**CHARTER TOWNSHIP OF VAN BUREN
PLANNING STAFF REVIEW AGENDA
Wednesday, July 1, 2020 – 3:00 PM
REMOTE Meeting: Instructions Below**

Title: Jiffy Lube- Preliminary Site Plan / Special Land Use review

File No.: VBT 20-012-SPR#1, Jiffy Lube / 9701 Belleville
Review: Site Plan Review #1
Plans Dated: May 20, 2020 (recd. by Township on May 26, 2020)
Review Date: June 23, 2020

Jiffy Lube Preliminary Staff Meeting – Review

**COMPOSITE SITE PLAN
CONSTRUCTION**

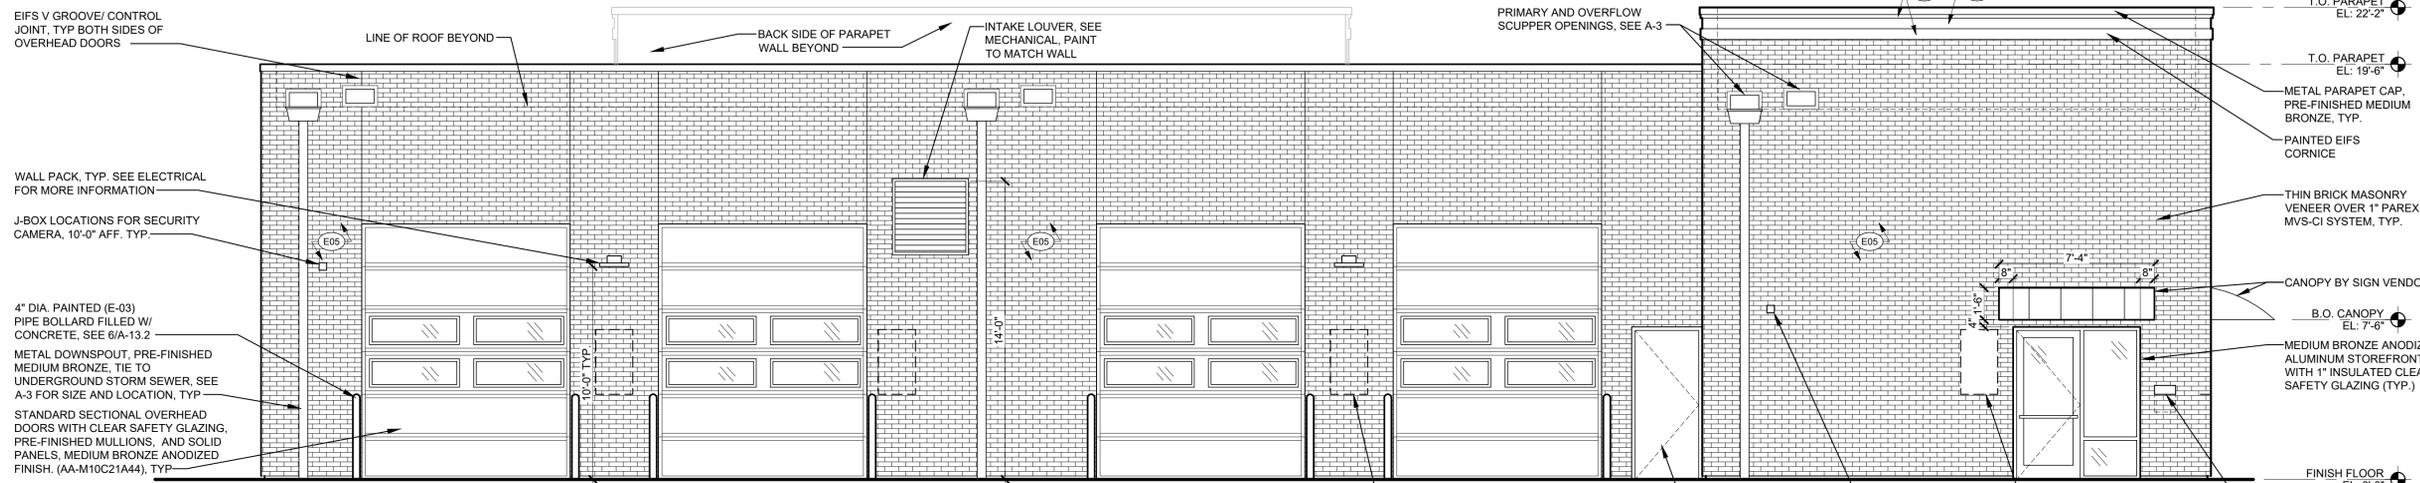
1. The internal discussion is still ongoing on the capacity and connection to the existing public 10-inch clay sanitary sewer along Belleville Road. Discussion will continue and further information will be provided at the Staff Review Meeting.
2. The Township has concerns with the ability to construct the sanitary sewer as currently proposed, due to existing utilities, above ground features, and the overall intersection configuration of Tyler Road and Belleville Road [See Image #1].
3. Applicant must complete a full topographic survey of the intersection, including but not limited to: existing utilities, manhole inventories, above ground site features, and conduct a private utility investigation (Miss Dig). Applicant must then indicate the method in which they plan to construct the sanitary sewer within the footprint of the existing features.

4. The 6-inch sewer service lead must tap into the proposed 10-inch sanitary sewer line downstream of the proposed manhole via a wye branch. Service connections cannot tap directly into manholes.

EXTERIOR ELEVATIONS
A-4

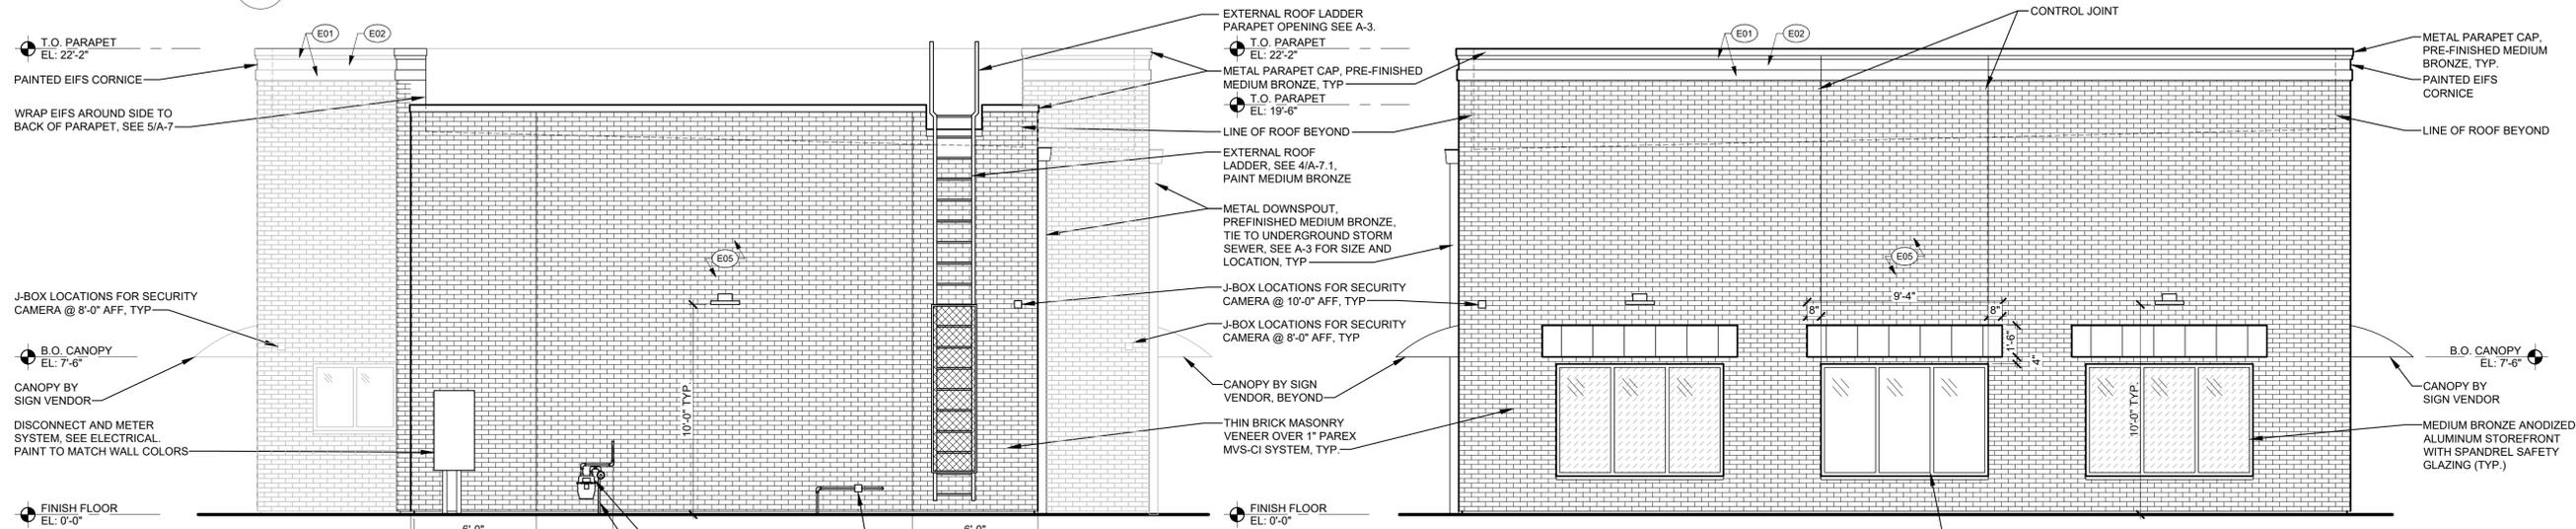
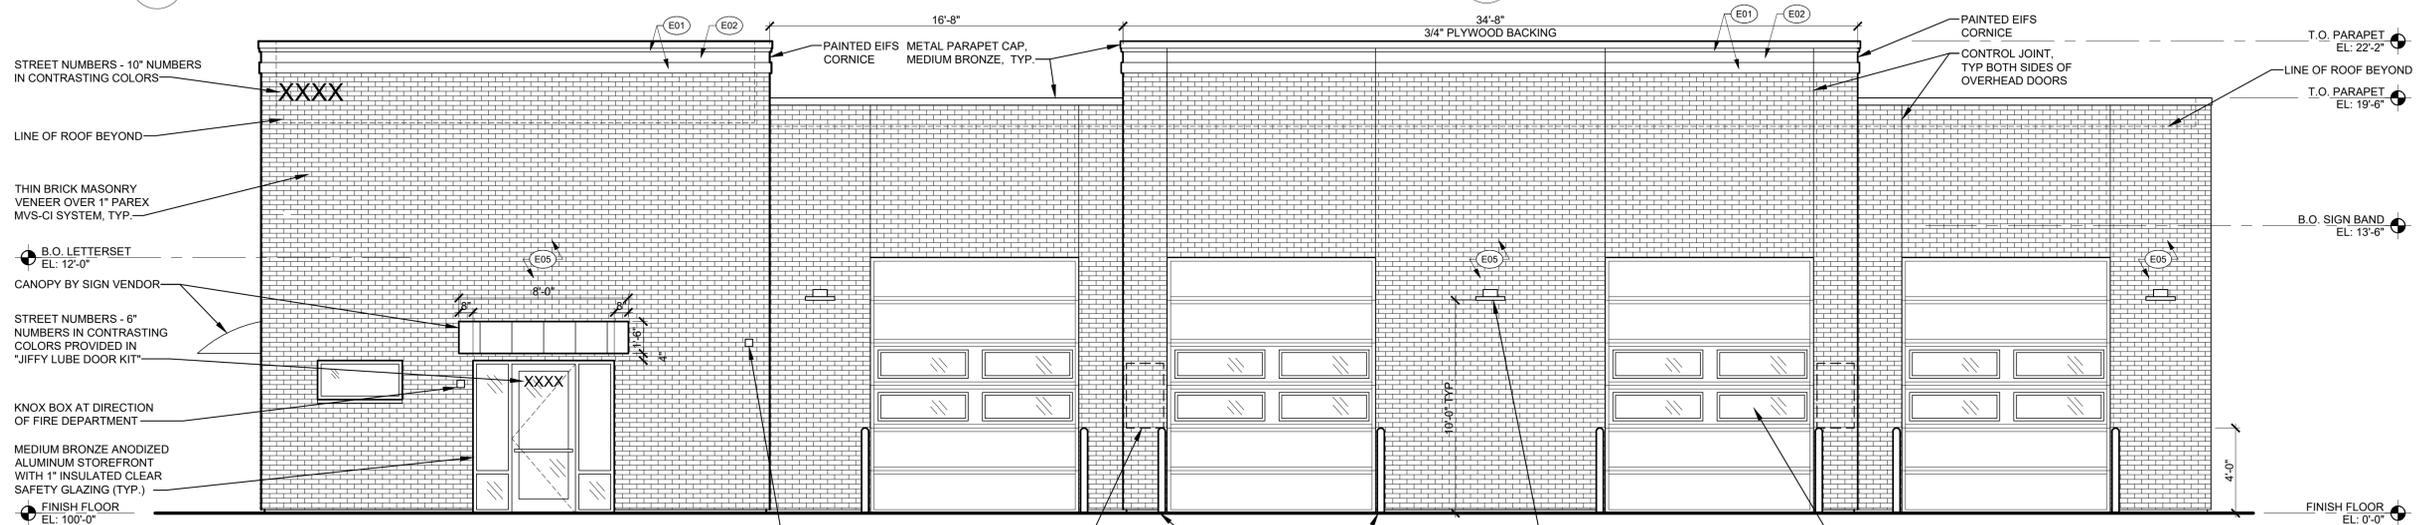
- d. Nonresidential buildings shall have a minimum of fifty (50%) glass at the ground floor level facing a street, with other exterior wall surfaces at upper stories not exceeding fifty (50%) glass. The proposed elevations do not comply.

- e. The intent of the BROD is to avoid developments with architectural elements that look applied, rather than incorporated. For example, building facades that incorporate canopies must provide a pitched roof component to provide depth and give an authentic appearance. The proposed architecture does not meet BROD standards. The use of thin veneer face brick is not acceptable. True brick, stone and other similar high-quality materials must be incorporated on a façade that has details in the form of banding, columns etc. As proposed the structure lacks visual appeal.

The proposed elevations for a building located at the entrance to a major store in the principal shopping district within the Township is not acceptable. The elevations would need a complete revision to incorporate some roof pitch details, higher quality materials, different design overhead doors that integrate into the building design and complete façade enhancement.
